Applicant : David W. Clarke et al.
Serial No. : 09/921,293
Filed : August 3, 2001
Page : 14 of 25

Amendments to the Drawings:

FIG. 15

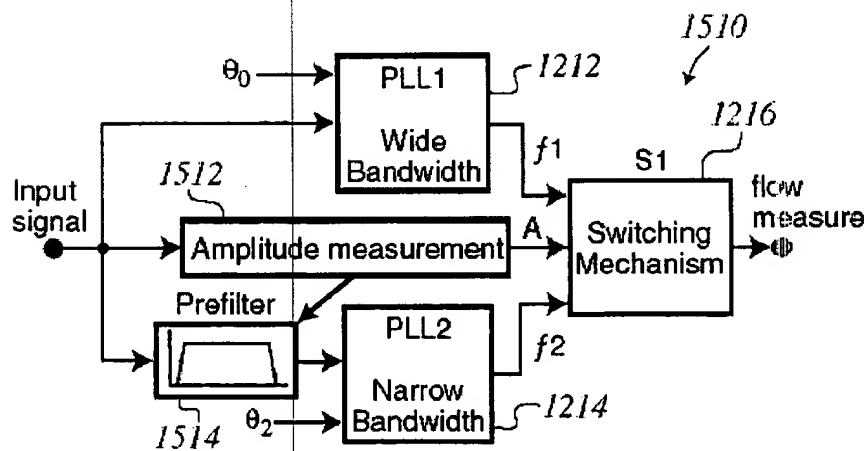
In Figure 15, (i) the arrow dangling from the lower left corner of prefilter 1514 has been removed, and (ii) an arrowhead has been added to the connection between prefilter 1514 and amplitude measurement 1512.

FIG. 29

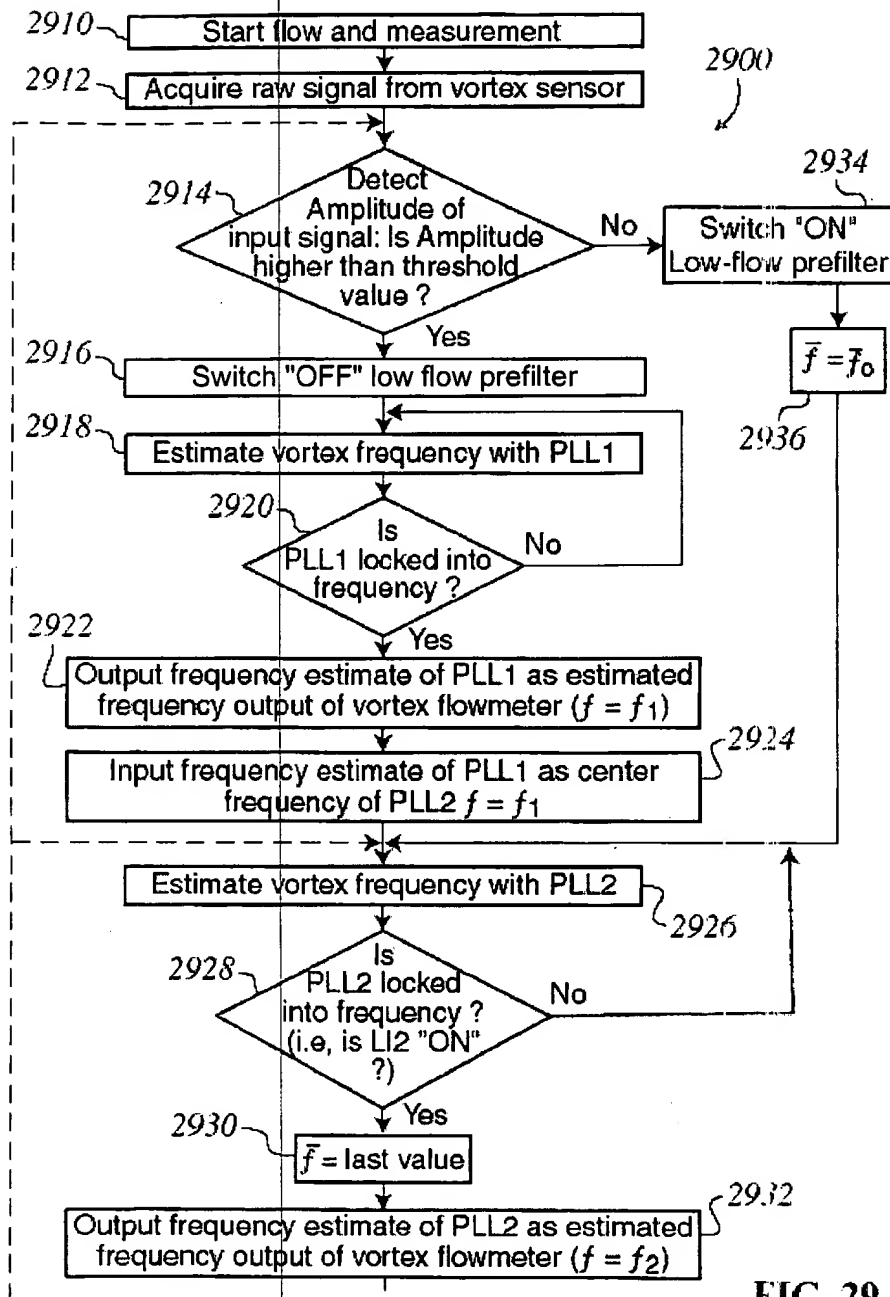
In Figure 29, "perfilter" has been changed to "prefilter" in block 2916, as shown in the originally-filed drawings.
